**Transport  
for NSW**

**Moorebank Intermodal Terminal Project, Environmental Impact Statement (EIS)  
State Significant Development No. 5056**

## Tab A Consolidated Recommendations

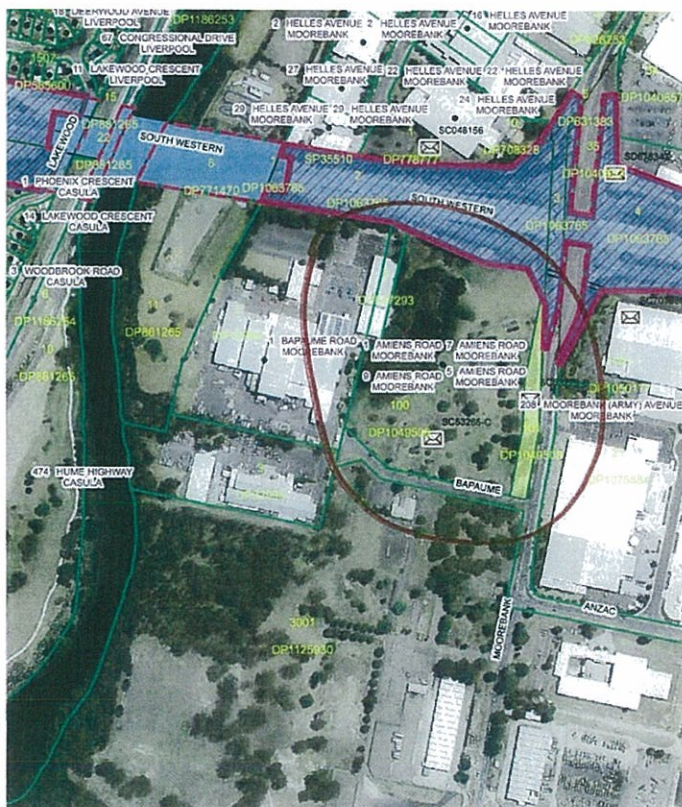
A strip of land has previously been dedicated as Public Road by private subdivision (DP 1049508) along the Moorebank Avenue frontage of the subject property as highlighted in yellow shading in attachment 1 and 2 below.

Roads and Maritime has no other current approved proposal that requires any part of the subject property for road purposes, noting that road widening and associated property set-back may be required along the M5 Motorway frontage as further planning is progressed to address the M5 weave issues.

Therefore, there are no objections to the development proposal on property grounds. However, as detailed in proposed conditions above, access is denied across the northern boundary of Lot 100 in DP1049508 on to the South Western Motorway.

Interlink Roads Pty Ltd (ILR) requires access to be retained for maintenance purposes to the proposed GPT pit detailed in the yellow text box in 'Maintenance Access requirements' in TAB B.
